PROPOSED TECHNICAL SPECIFICATION CHANGE

SEQUOYAH NUCLEAR PLANT UNITS 1 AND 2

(TVA-SQN-TS-93-10)

DESCRIPTION AND JUSTIFICATION FOR AMENDING

FIGURE 1

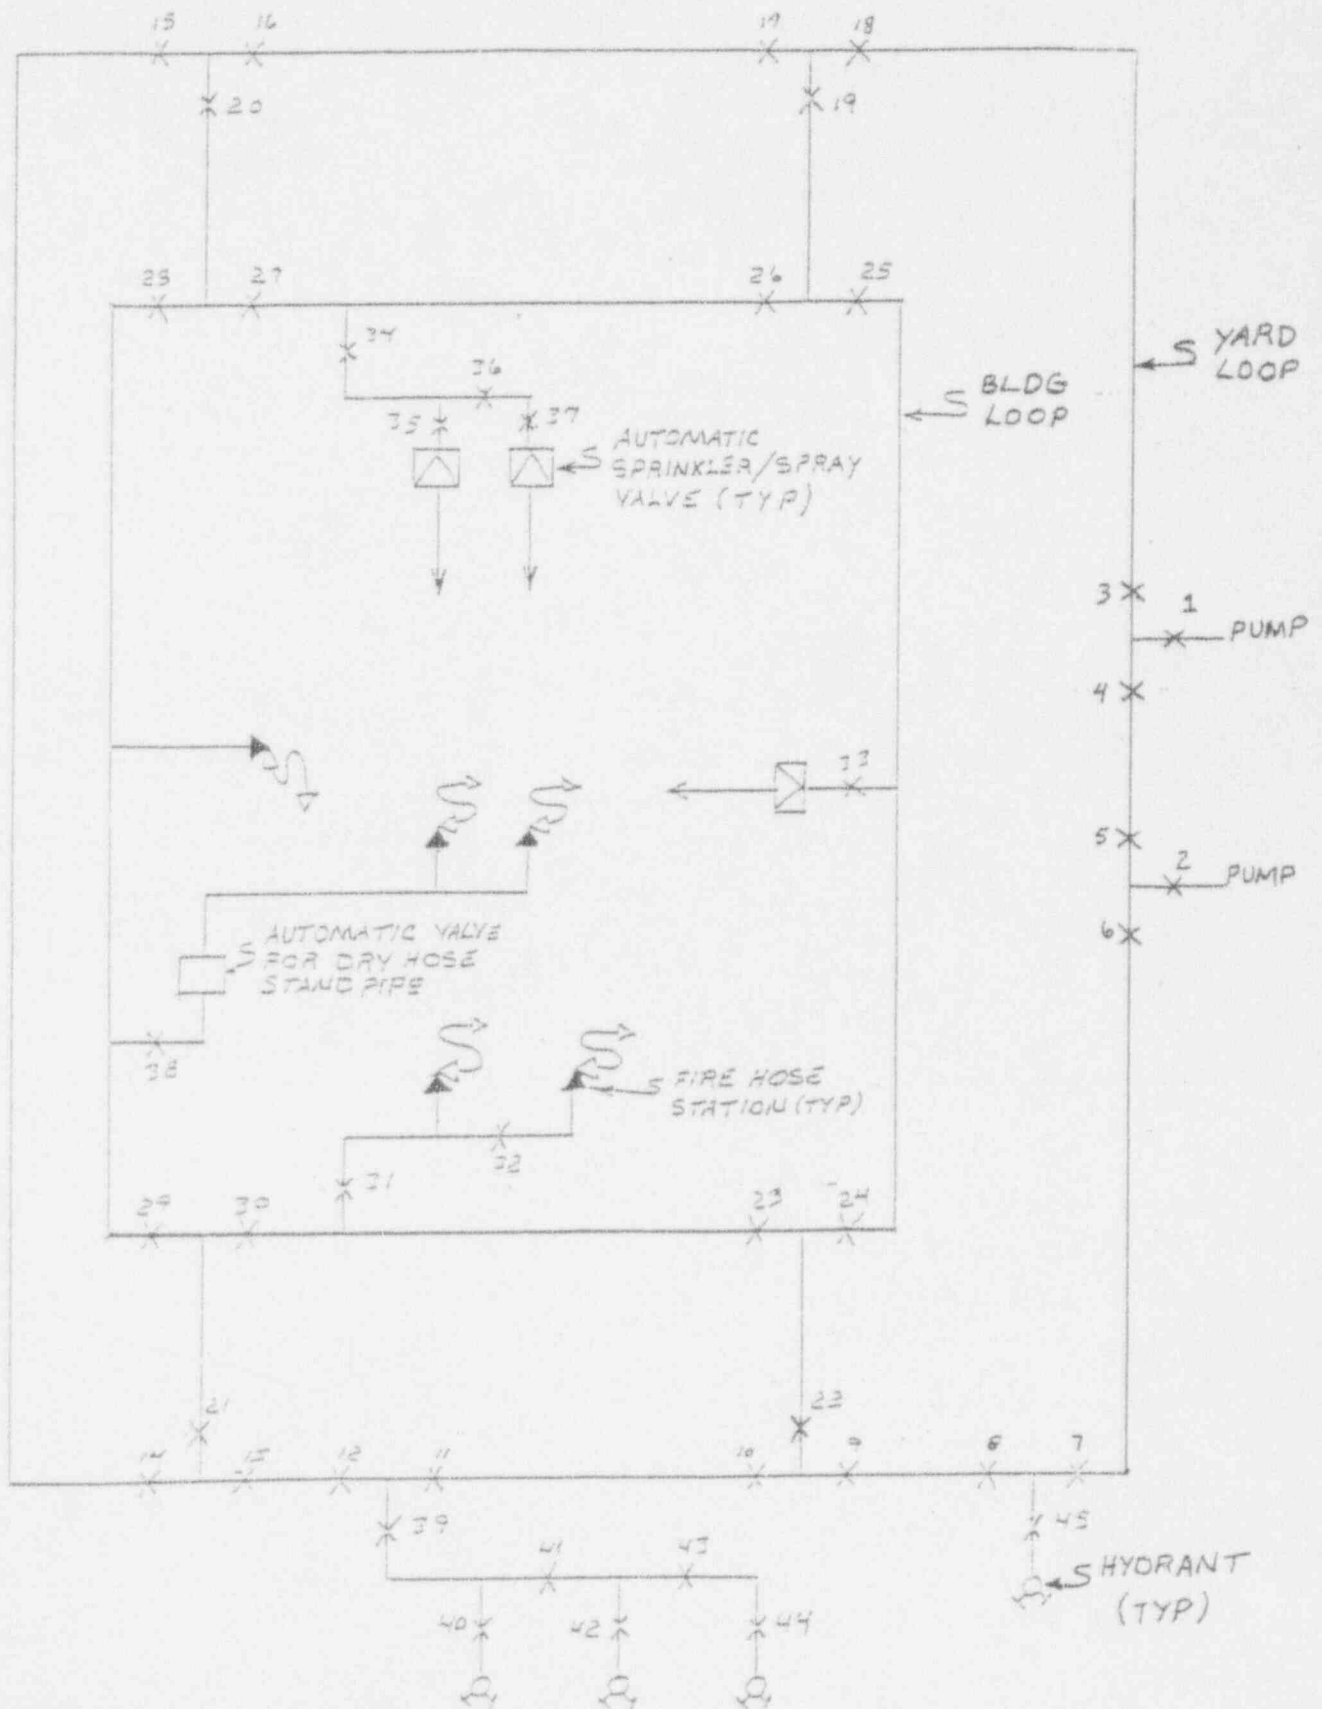
TVA's proposed change to LCO 3.7.11.1.b clarifies the boundary for an operable flow path by establishing the boundary at the first valve off the header (i.e., yard loop or building loop) leading to the particular end device(s) (i.e., spray and/or sprinkler system, or hose standpipe) rather than the last valve ahead of the particular end device(s). Figure 1 provides a representation of SQN's fire protection piping configuration. The boundary for an operable flow path that currently exists in LCO 3.7.11.1.b has resulted in an unnecessary overlap between TS LCO requirements for both the end device(s) and the flow path. This is an undesirable condition that leads to multiple LCO entries and action requirements for cases when preplanned maintenance and testing of SQN's fire protection system do not affect the flow path (i.e., only the end device[s] has been removed from service).

"An OPERABLE flow path capable of taking suction from the forebay and transferring the water through distribution piping with OPERABLE sectionalizing control or isolation valves up to the first valve off the loop header that isolate:

1. Spray and/or sprinkler system(s) required to be OPERABLE per Specification 3.7.11.2, or
2. Hose standpipe(s) required to be OPERABLE per Specification 3.7.11.4."

FIGURE 2

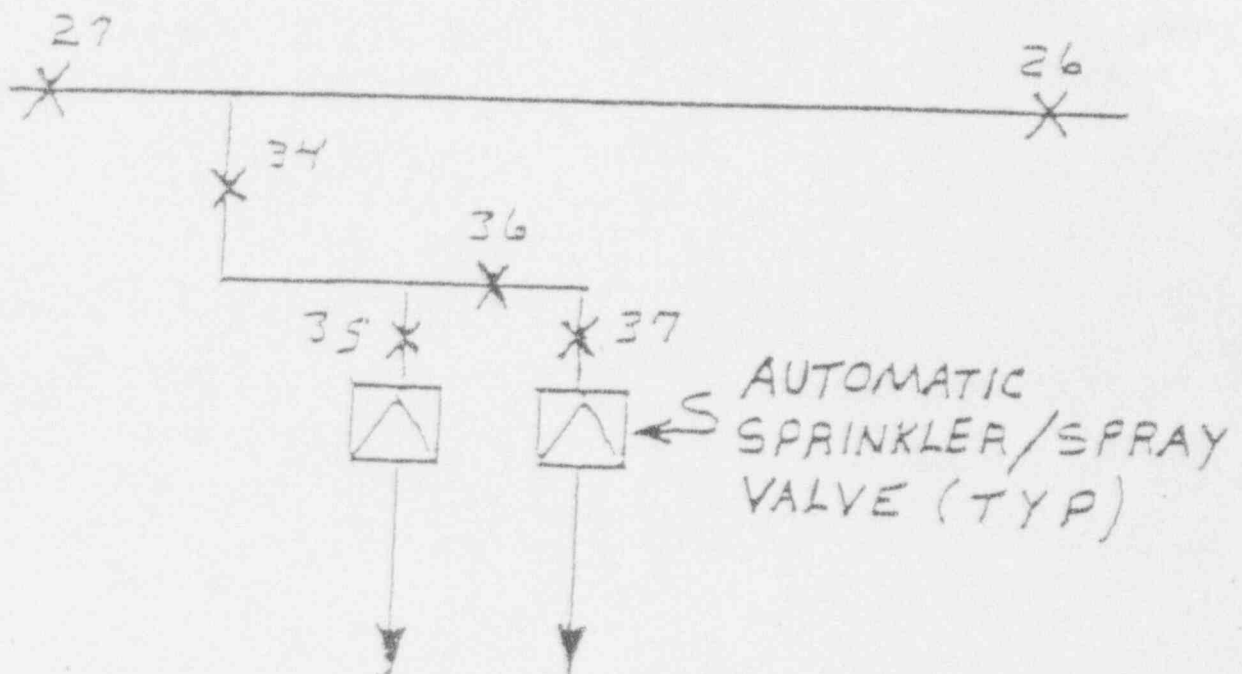
An example of this problem is illustrated in Figure 2. When a sprinkler system valve (Valve No. 37) is closed, the operator is required to enter the LCO for the end device (i.e., LCO 3.7.11.2 for the affected sprinkler). However, if Valve No. 34 were to be closed to perform repair on the piping, the operator would be required to enter the flow-path LCO (LCO 3.7.11.1.b) and the sprinkler-system LCO (LCO 3.7.11.2) under SQN's current TS requirements. Since the loop flow path is unaffected by the isolation of Valve No. 34, entry into LCO 3.7.11.1.b for flow path is inappropriate and results in multiple TS action requirements. TVA's proposed change would establish appropriate flow-path operability boundaries that would result in a more appropriate application of TS LCOs for SQN's fire protection systems. It should be pointed out that in this example, isolation of Valve Nos. 26 and 27 would have the same net effect as isolating Valve No. 34. TVA realizes that other valve configurations may exist that will have the same net effect as taking credit for the first valve off of the header that will also not affect the fire suppression water system's capability. However, difficulty remains in generically defining the boundaries for these other potential valve configurations.
